## CARRIER, PERSONNEL, FULL TRACKED, FV432 MK 2 AND 2/1

### GENERAL INSTRUCTIONS AND INDEX

Fig 1. Modification to hatch  
(Dimensions in mm)

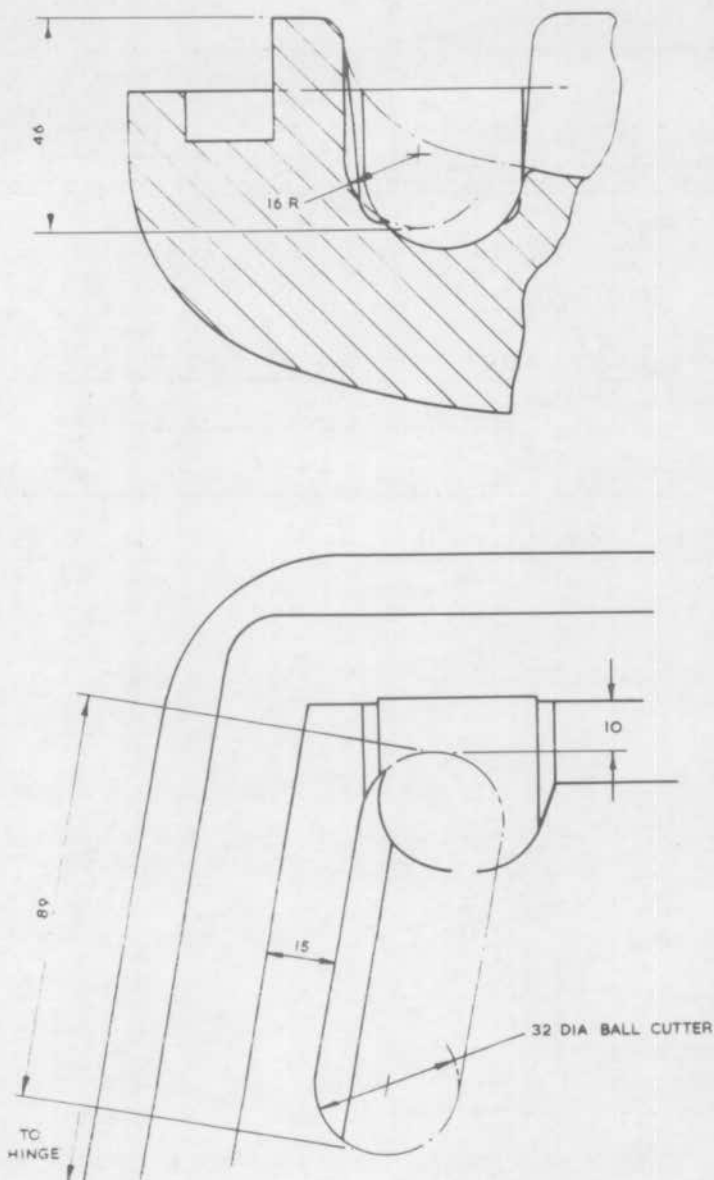
4. Remove hatch and machine as detailed in Fig 1.

Fig 1 - Remote trigger location details

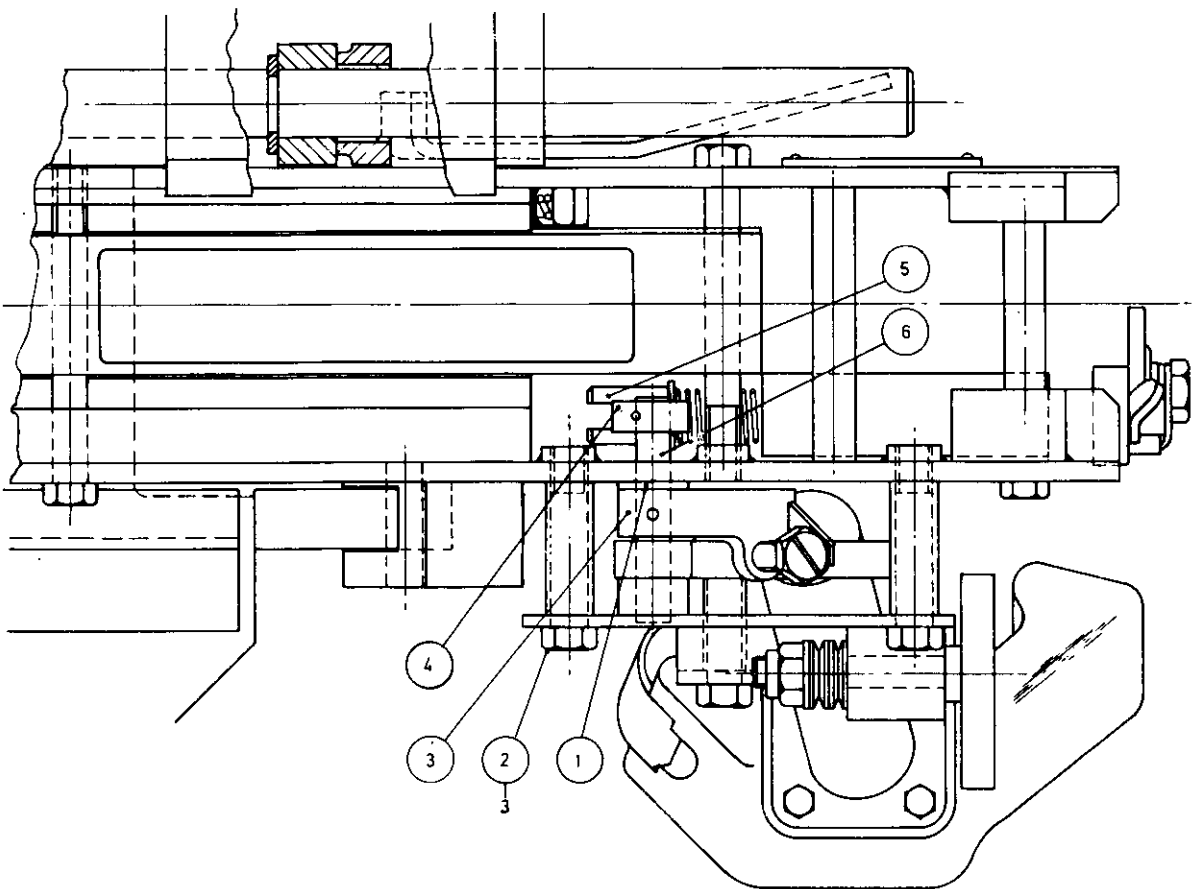
- c. Reduce thickness of washer G1/5310-99-120-5770 to maintain 0.010 in. clearance when fitted.
- d. Fit modified washer to mechanism as shown at item 1.
- e. Ensure arm trigger lever (item 4) moves freely in the trigger plunger (item 5).

Note: If arm trigger lever does not move freely in the trigger plunger it will be necessary to fit and drill a new pin (item 6).

Fig 2 - Shock absorber mattress - hole and slots detail  
(Dimensions in inches)

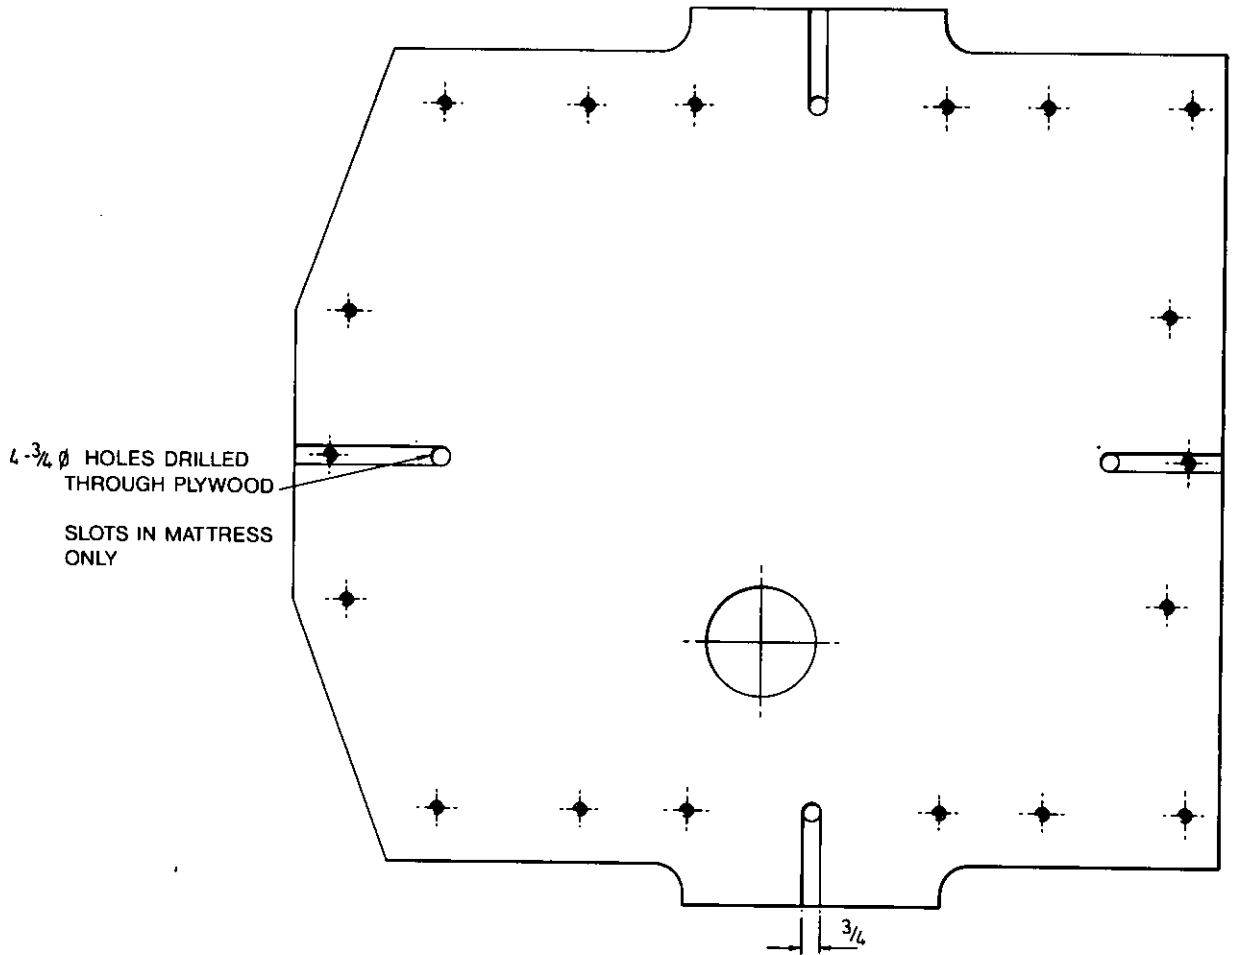
c. Cut slots in the mattress from the holes to the outer edges as shown in Fig 2.

Note: The mattress is only to be slotted to the depth of the plywood base.

Fig 1 Replacement of the front access cover hinges (hatch), set from the hull hinges

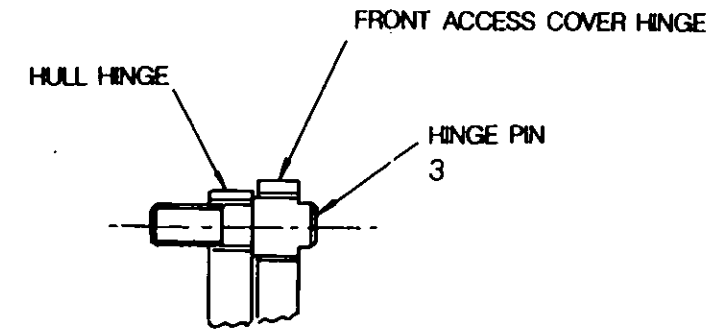
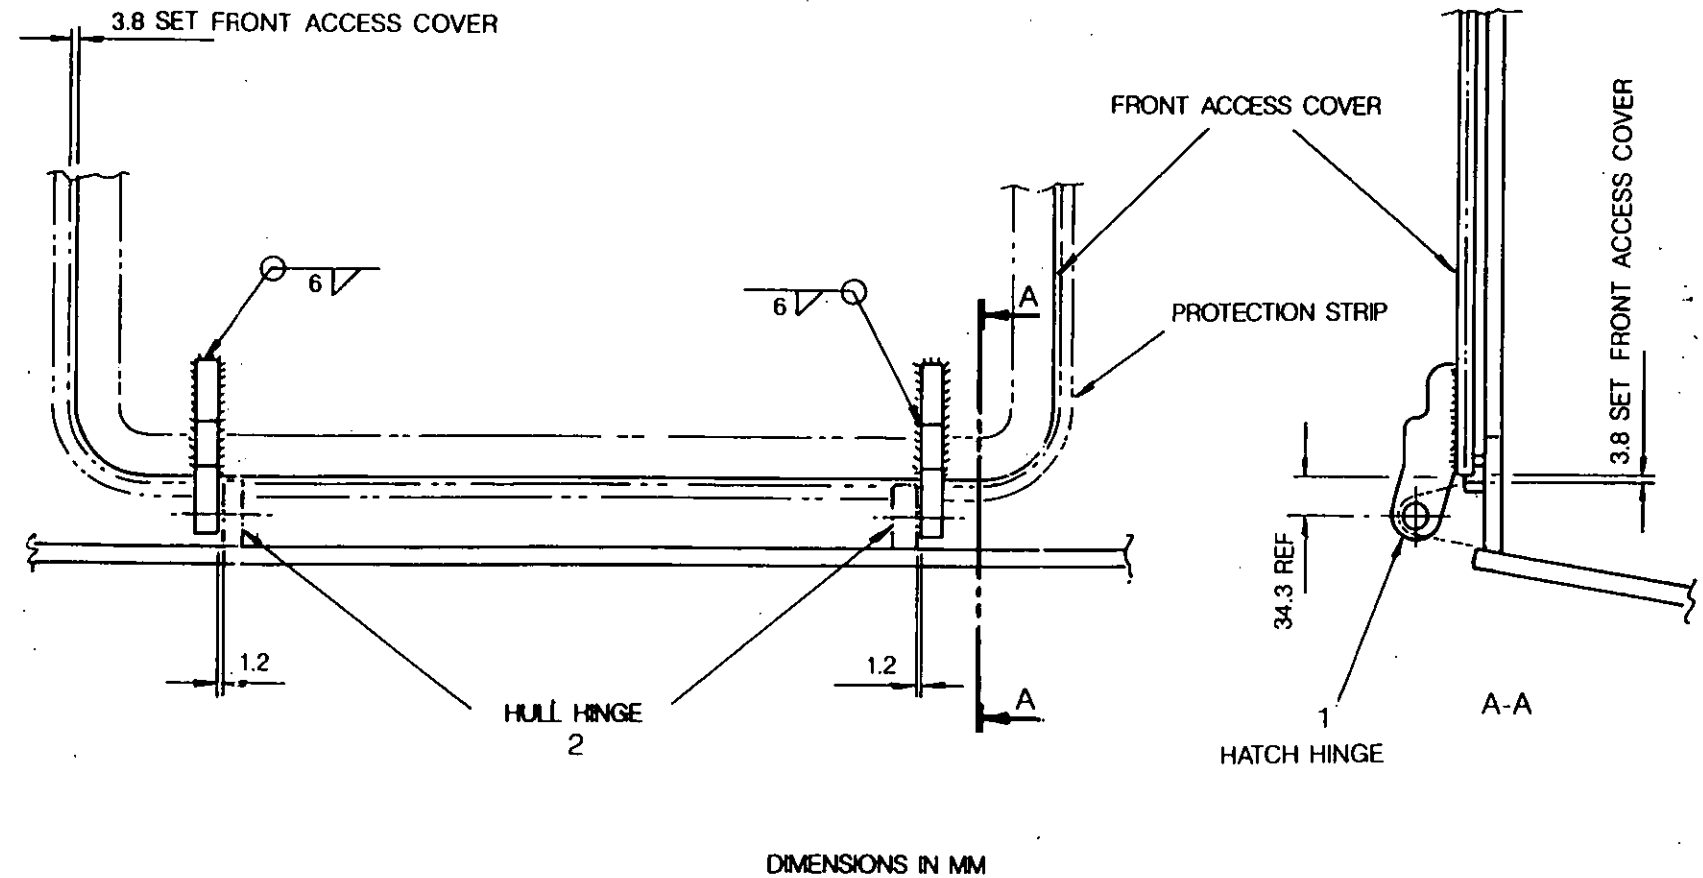
9.1 To replace the front access cover hinges (hatch), follow the repair scheme detailed at Fig 1.

- (1) This scheme is to be used when hinges on front access cover assembly are replaced.
- (2) Welding is to be carried out to EMER Wksp O 360 Chap 12, using a 3.25 mm rod.
- (3) Before commencing with repair, remove front access cover from the vehicle.

- 1 Remove existing access cover hinges by gas cutting or gouging within 6 mm of armour plate.
- 2 Remove remaining metal by grinding. Avoid overheating of armour plate.
- 3 Finish smooth armour plate and protective strip and use NDT (penetrant dye) to establish that no surface cracks are present.

- 4 Locate front access cover on vehicle and set to 3.8 mm from inside edge of protection strip and clamp in position.
- 5 Set first front access cover hinge to 1.2 mm from first hull hinge and align hole centres using hinge pin (item 3). Make initial root weld along bottom edge of hinge and cover.
- 6 Set second front access cover hinge to 1.2 mm from second hull hinge and align hole centres using hinge pin (item 3). Make initial root weld along bottom edge of hinge and cover.
- 7 Check accuracy of hinge for position and squareness and use hinge pin (item 3) to ensure clearance when pivoting. See detail 'B'.
- 8 Unclamp front access cover and remove from vehicle.
- 9 Complete welding of front access hinges as shown.
- 10 Inspect.
- 11 After 72 hours, check with NDT that welds and plates are crack free.
- 12 Finish to DEF STAN 03-32 Part 2, colour as per contract.

Fig 2 Replacement of the front access cover hinges (hull), set from the hatch hinges

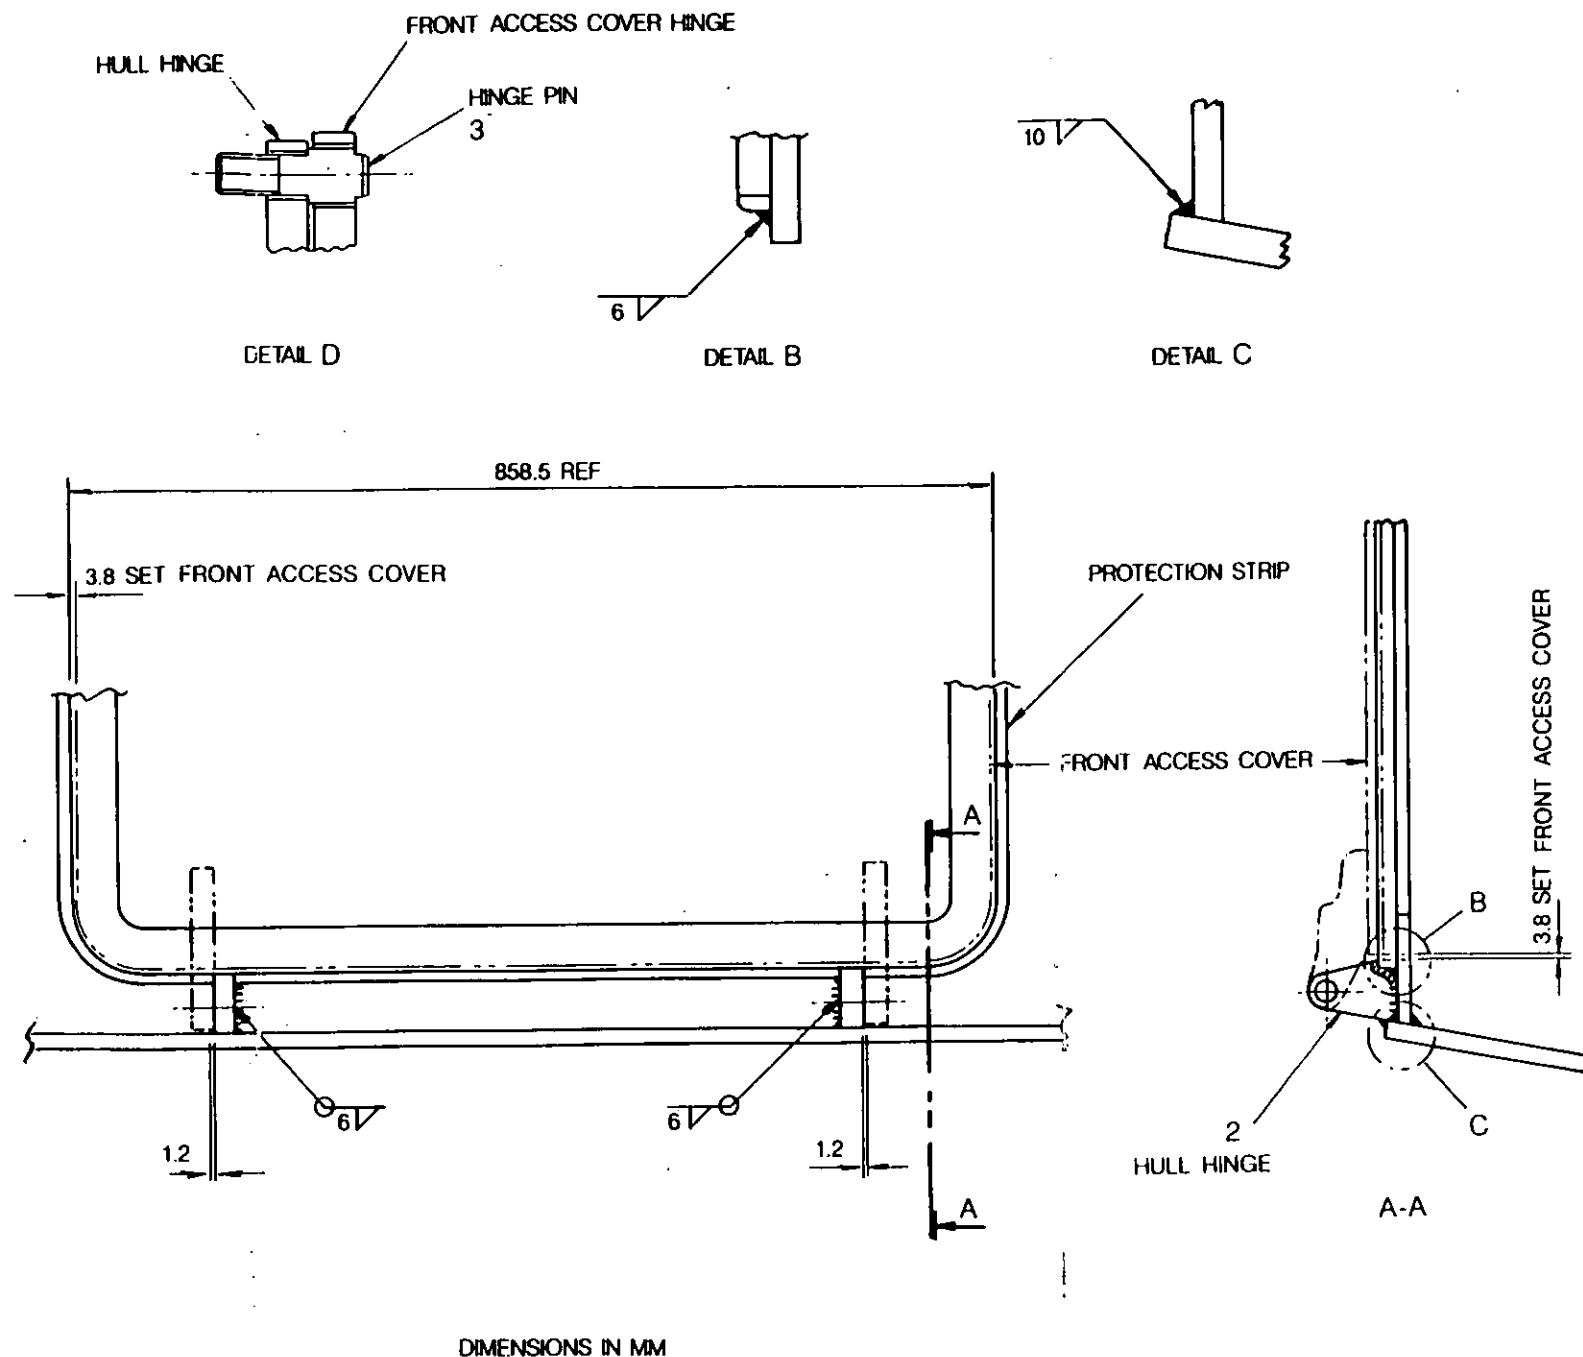
9.2 To replace the front access cover hinges (hull), follow the repair scheme detailed at Fig 2.

- 10 Complete fillet welding of hull hinges as shown.
- 11 Replace weld removed from hull nose plates during ops 1, 2 and 3 with a fillet weld as indicated as detail 'C'.

- 12 Inspect.
- 13 After 72 hours, check that welds and plates are crack free.
- 14 Finish to Def Stan 03-32 Part 2, colour as per contract.

Fig 3 Replacement of the front access cover hinges (hull), set to the original build standard

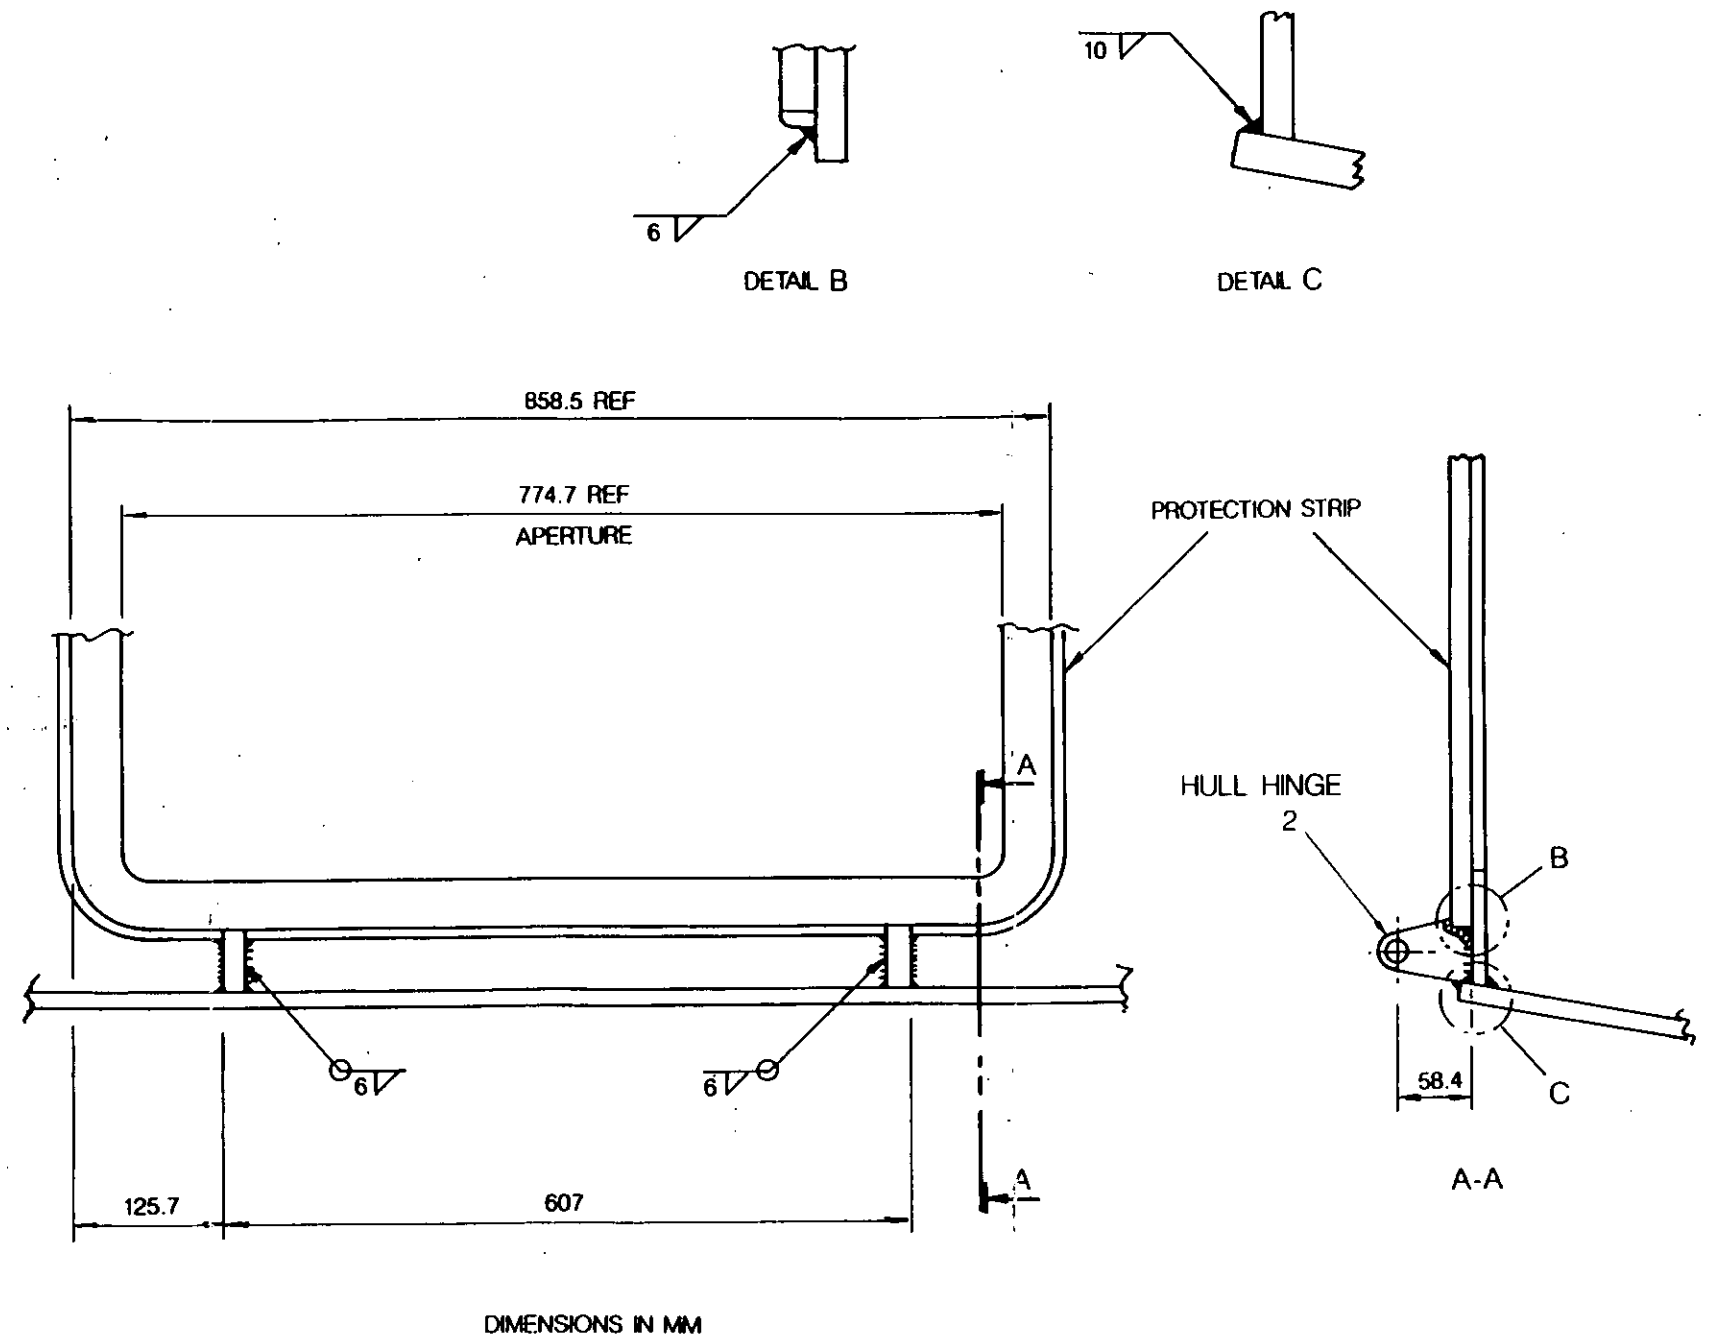
9.3 To replace the front access cover hinges (hull and hatch), follow the repair scheme detailed at Fig 3, followed by the repair scheme detailed at Fig 1.

(1) This scheme is to be used when the hinges on hull and front access cover are to be replaced. Use this scheme to replace the hull hinges, followed by the scheme detailed at Fig 1, to replace the front access cover hinges.

13 After 72 hours, check with NDT that welds and plates are crack free.
